Issue Paper (IP)

IP Number: CIP EASA 2023-08\_R02

<b>Title:</b>	Removal of not MSG-3 related Steps from the L/HIRF Protection Analysis Methodology and Logic Diagram
<b>Submitter:</b>	EASA

Applies To:	
MSG-3 Vol 1	X
MSG-3 Vol 2	X
IMPS	X

Figure 2-6-1.3 L/HIRF Protection MSG-3 Logic Diagram (part 2)

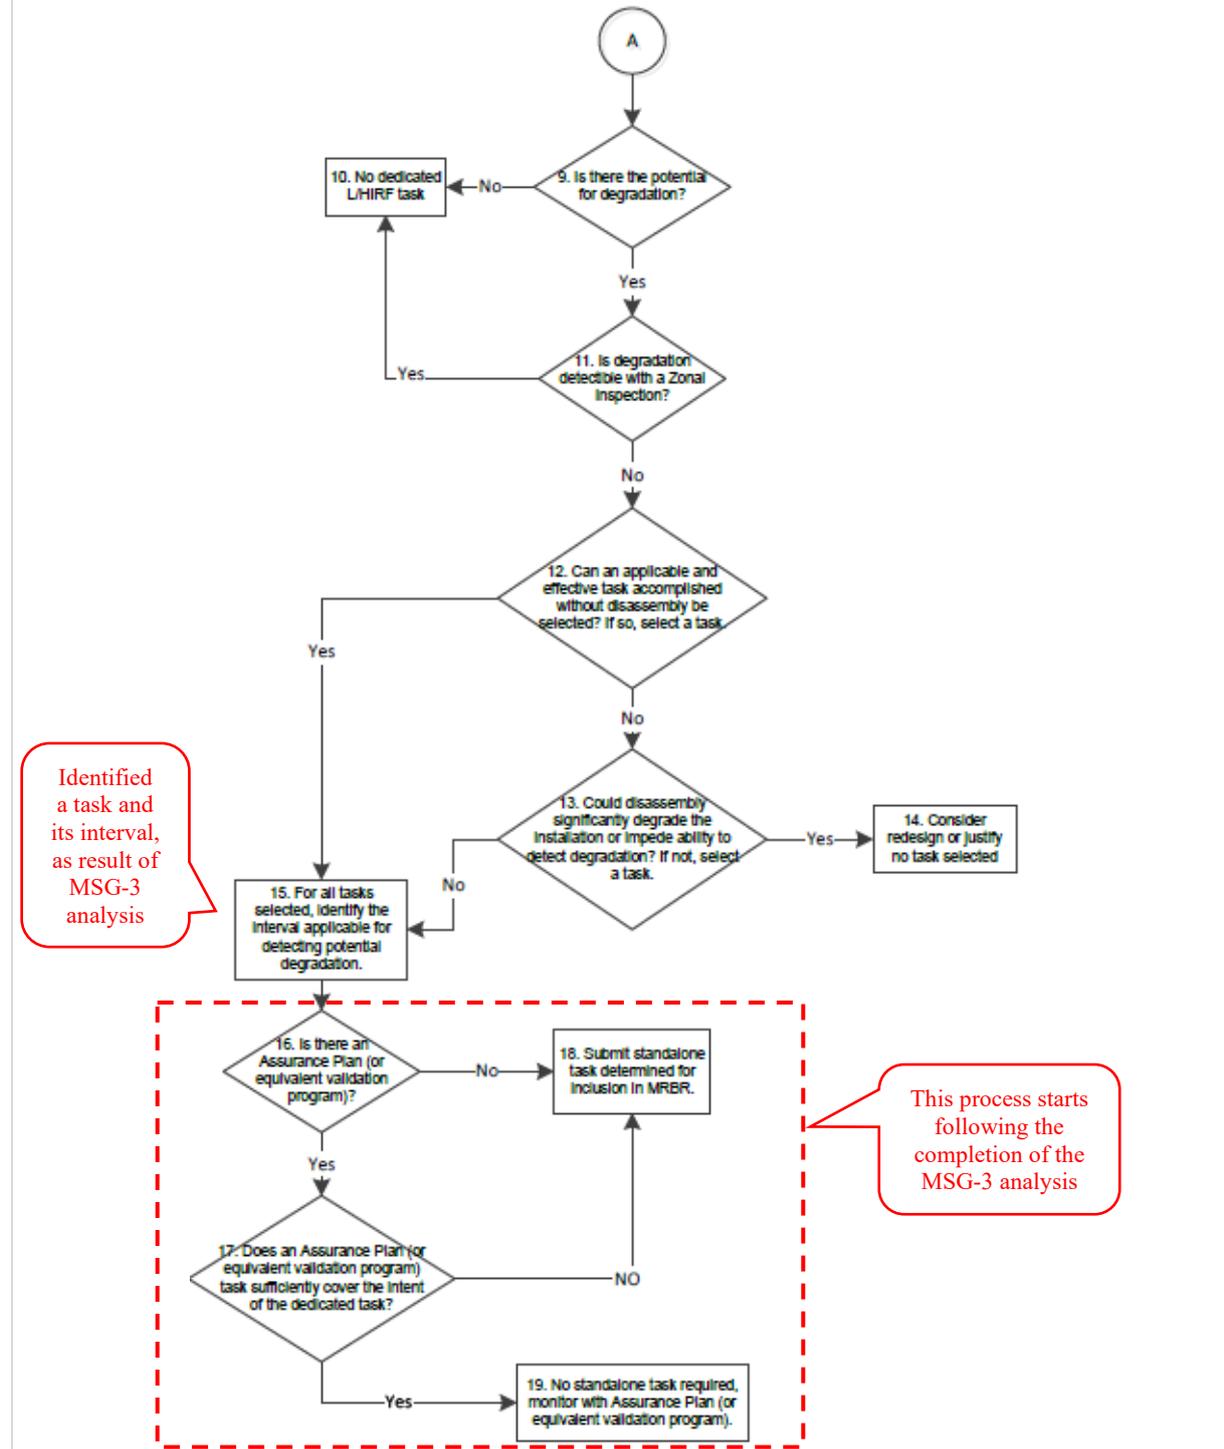
The following steps, from Step 16 to Step 19, are instead describing a process that is clearly not dependent upon the MSG-3 methodology.

Therefore, to be consistent with the dispositions approved by the IMRBPB within IP 129, guidance related to the impact that an L/HIRF Assurance Plan (or equivalent validation program) may have on the publication in the MRBR of L/HIRF MSG-3 derived tasks, as described in Steps from 16 to 19, should be removed from the MSG-3 document.
